Access Compliance Report

Public Rights-of-Way

(Curb Ramps)

| Intersection ID: 28409 | Main Street: LAUREL_RUN_DR | Cross Street: N/A | Location: | E |

| ADA ID: A6B210DCB444 | Ramp Type: BlendTrans2 | Initial Pass/Fail: Fail | Overall Compliance: No | Severity Score: 25 |

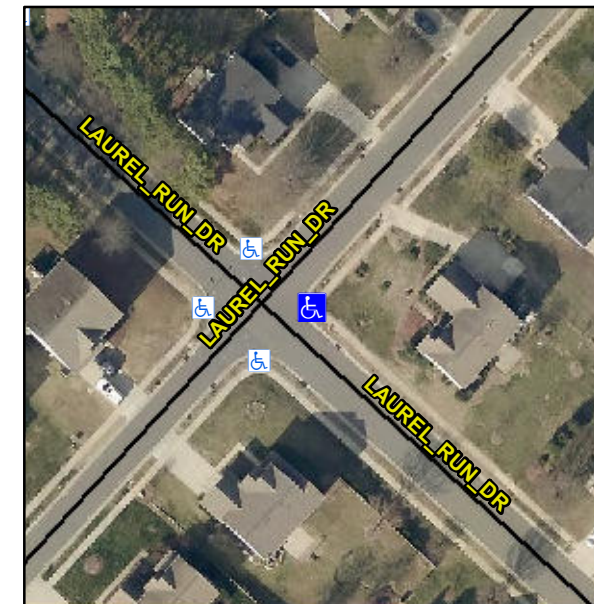
R304.5.3

| Compliance | Description | Data | Compliance | Description | Data |
|------------|-----------------------|-------|------------|-----------------------------|-------|
| Yes | Ramp Width (in) | 50.0 | No | BlendTrans XSlope (%) | 13.8 |

Remove & Replace Curb Ramp With Two New Directional Ramps or Equivalent.
